BRIAN ALBRIGHT DIRECTOR DEPARTMENT OF PUBLIC WORKS 5510 OVERLAND AVENUE, SUITE 410 SAN DIEGO, CA 92123-1237 (858) 694-2212 www.sdcounty.ca.gov/dpw/

FROM: Zoubir Ouadah, County Traffic Engineer

13th Street Bridge - Traffic Impact Analysis Addendum

Figure 1

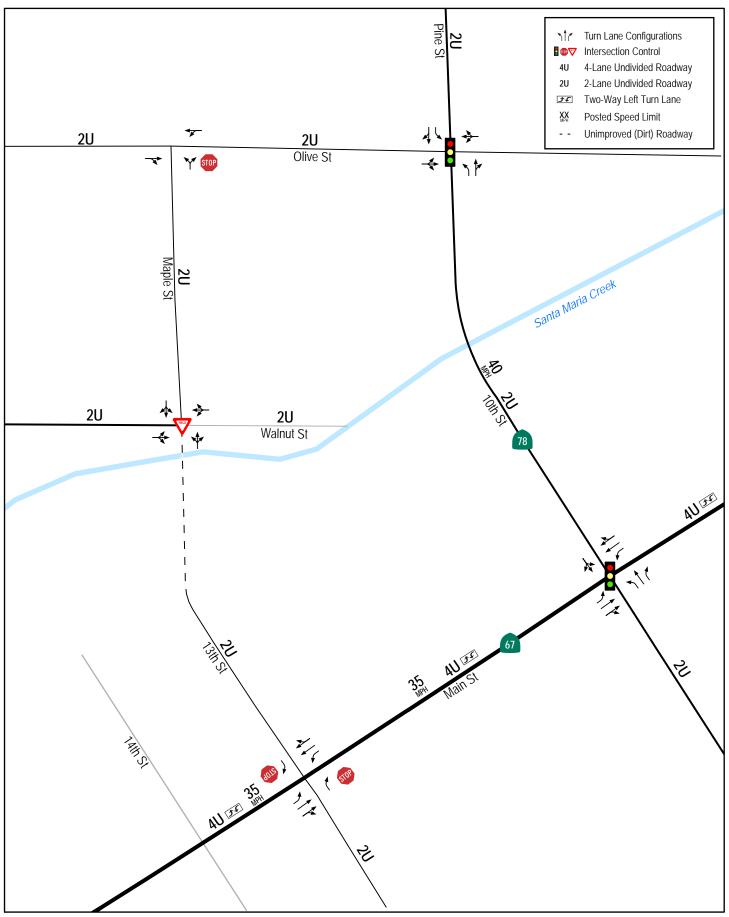
Based on the scope of the 2013 TIA and 13<sup>th</sup> Street Bridge – Data Validation Memorandum, a total of seven (7) roadway segments and five (5) intersections (Figure 1) were evaluated:
